# REPORT FOR ACTION

# **Application for Fence Exemption – 7 Ralston Avenue**

Date: May 30 2022

Attachment 2: Measurement of gate

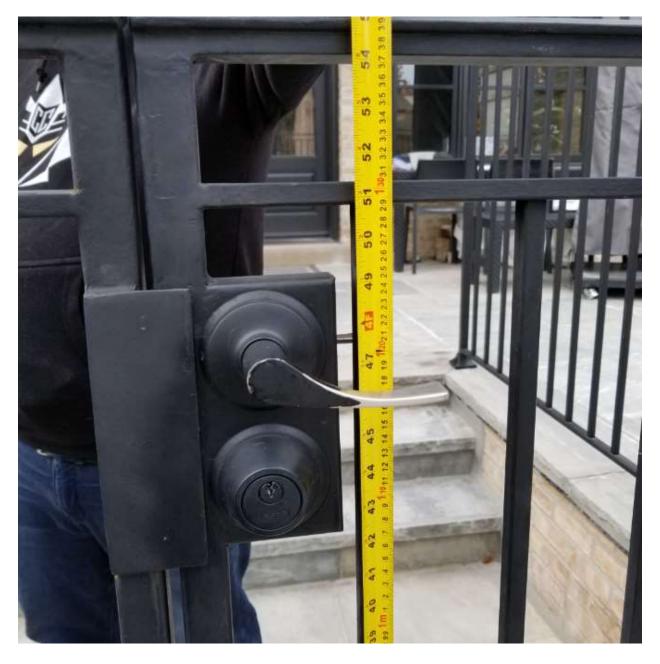
GENERAL LOCATION	SPECIFIC LOCATION	CONSTRUCTION & DEFICIENCY	BY-LAW SECTION & REQUIREMENT*
Rear yard	Rear yard – swimming pool enclosure	Wrought iron gate that measures 1.2-1.4 meters	447-1.3C (6.C.1) – Access Protection.
			Minimum 1.5 meters above grade

1. Refuse to grant the application for an exemption permit, by the owner(s) of 7 Ralston Avenue, to maintain a wrought iron gate in the rear yard that measures 1.4 meters (4.7 feet) and has a wrought iron horizontal bar that provides a 1.2 meter (4 feet) distance from the horizontal bar to the locking mechanism, which does not comply with the Toronto Municipal Code, Chapter 447, Fences, specifically section 447-1.3C (6.C.1) – Access Protection.
